Response to Highways England Deadline 7 Documents 8.80, 8.83, 8.84, 8.86 & 8.89:

8.80 Applicant's Comments on any Additional Information or Submissions Received by Deadline 6

Figure 7.6: AADT 24hr flows differences (DS-DM)

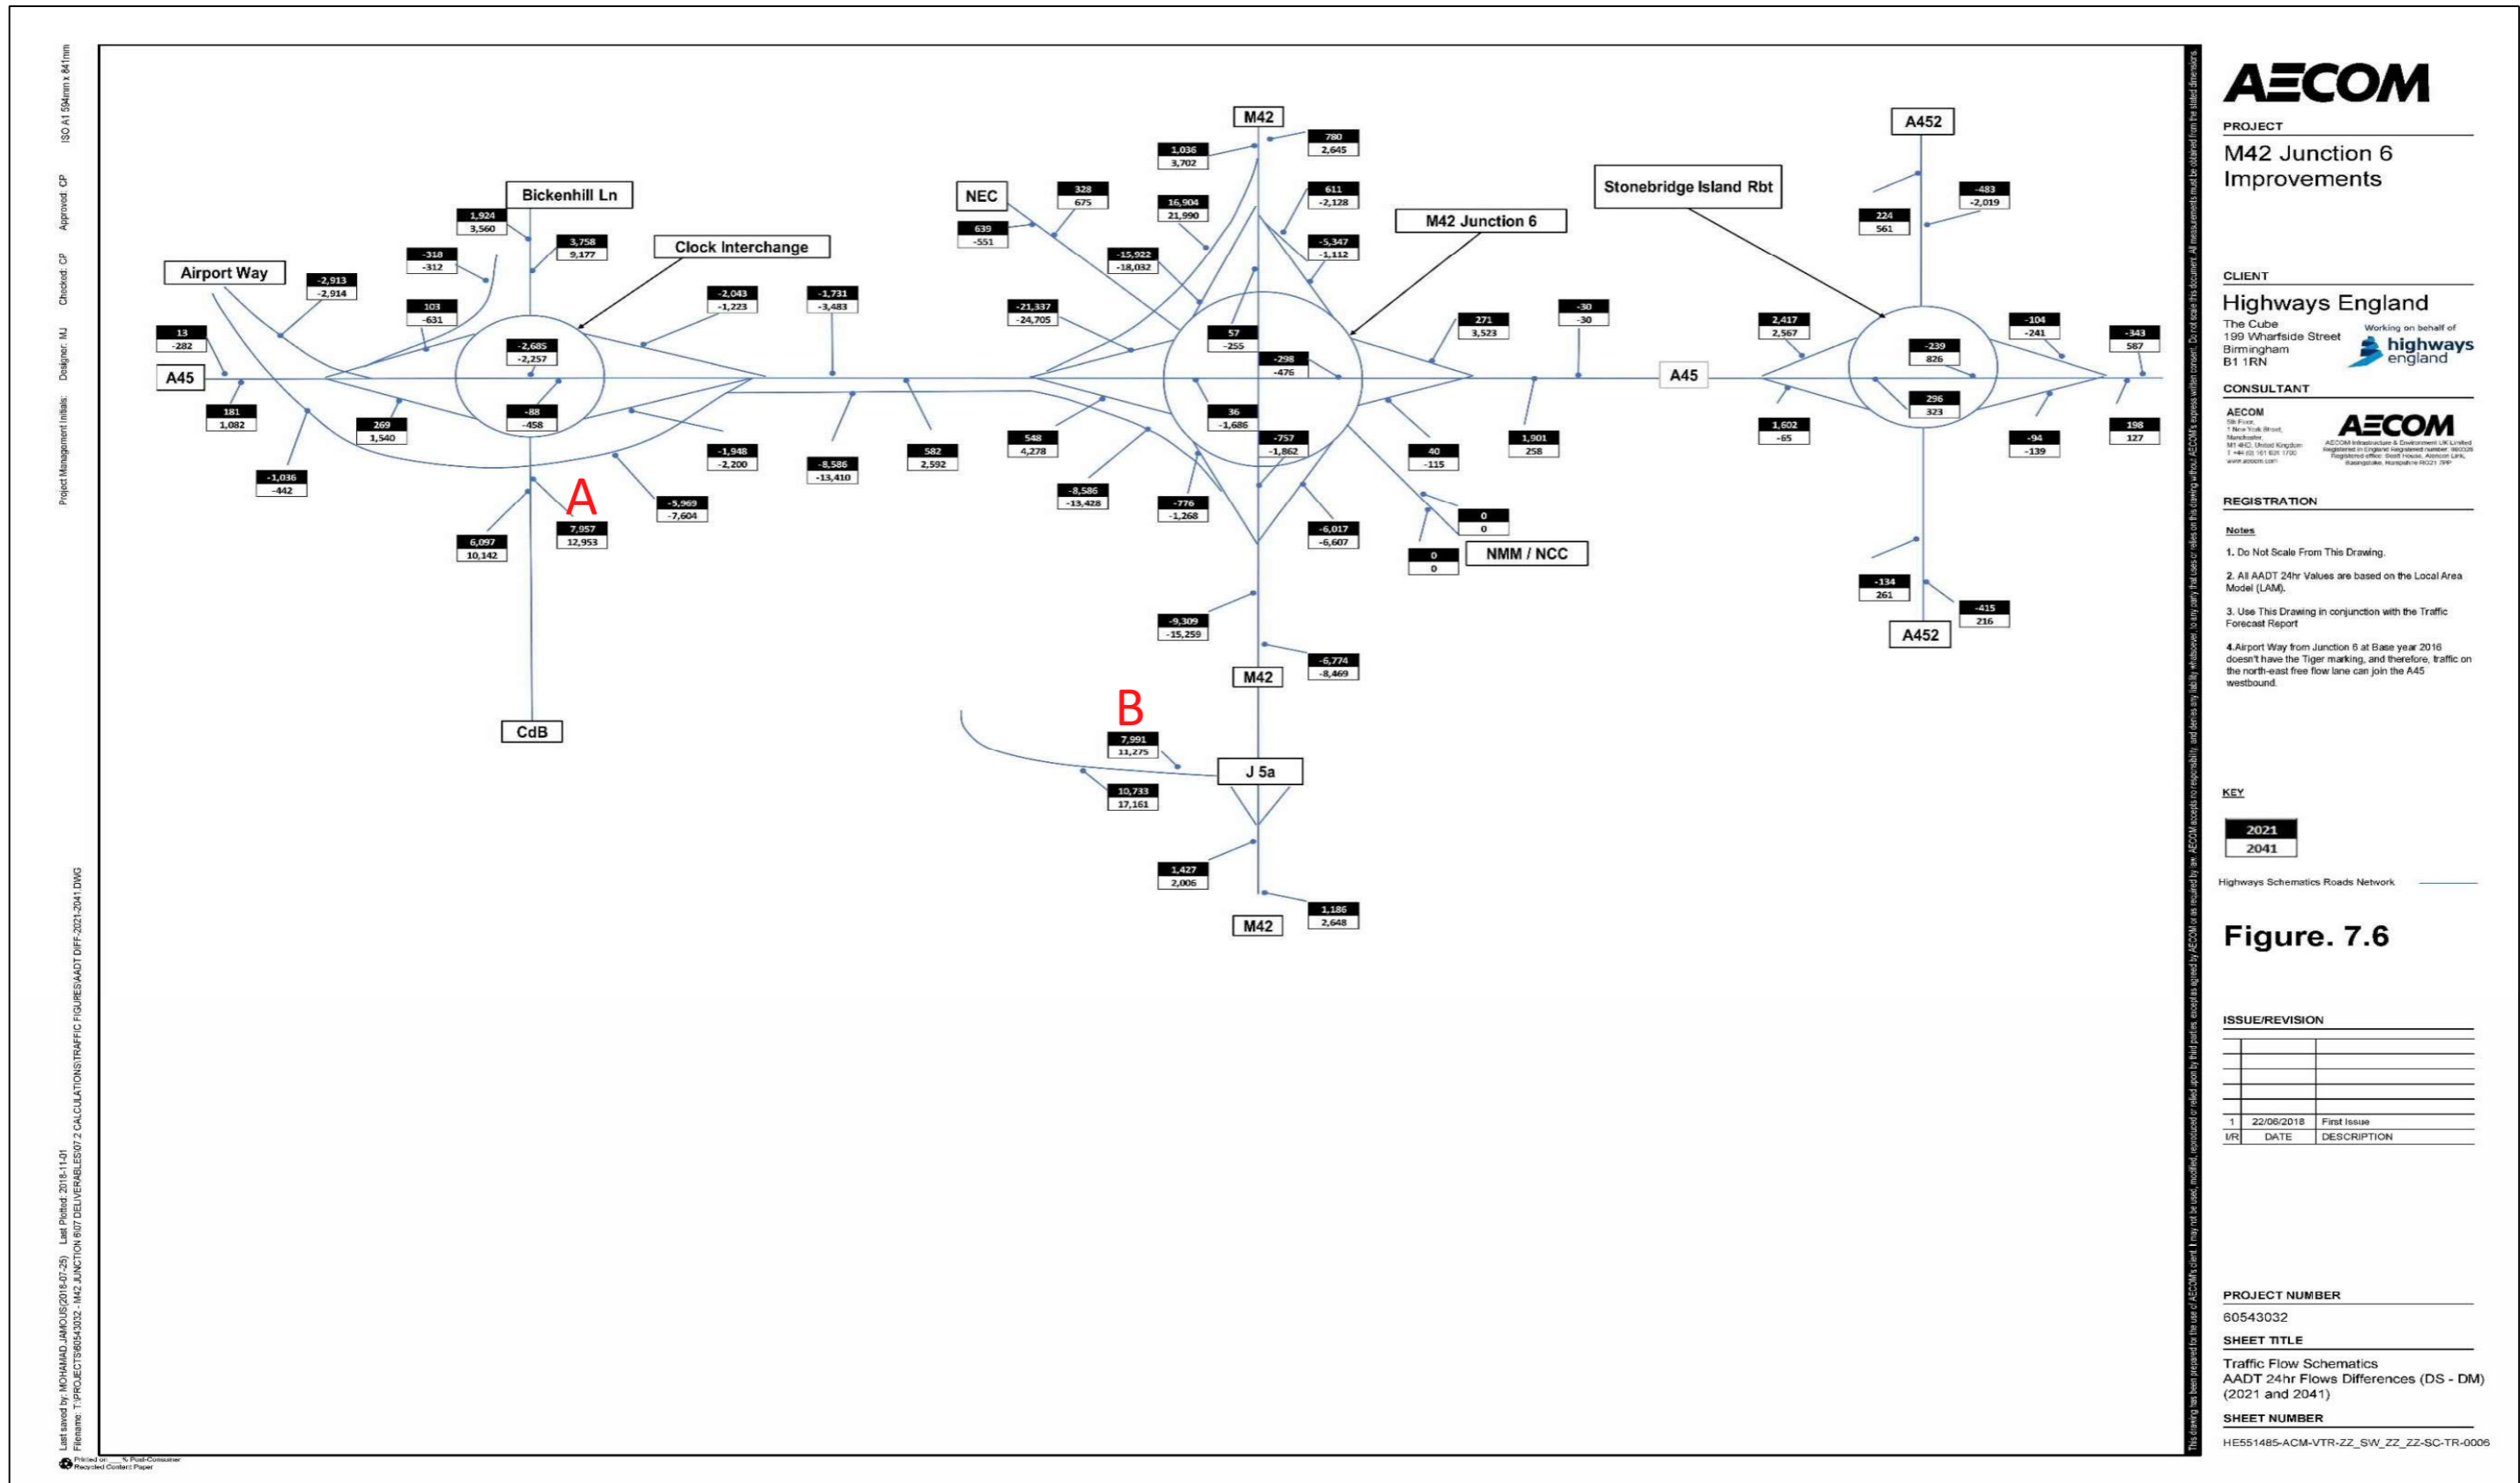
Figure 7.6 – AADT 24hr Flows Differences (DS-DM) (2021 and 2041)

- Unfortunately Figure 7.6 omits the works between Clock Interchange and Hampton Lane Roundabout but does include Junction 5a
- In 2021, 7957 more vehicles will exit Clock Interchange traveling south and 7991 of these vehicles will continue onto the Mainline Link road. Where have the extra 34 vehicles come from?
- In 2041, 12953 more vehicles will exit Clock Interchange traveling south and 11275 of these vehicles will continue onto the Mainline Link road. It appears there will be an increase of 1678 vehicles using the Realigned Catherine de Barnes Lane in 2041
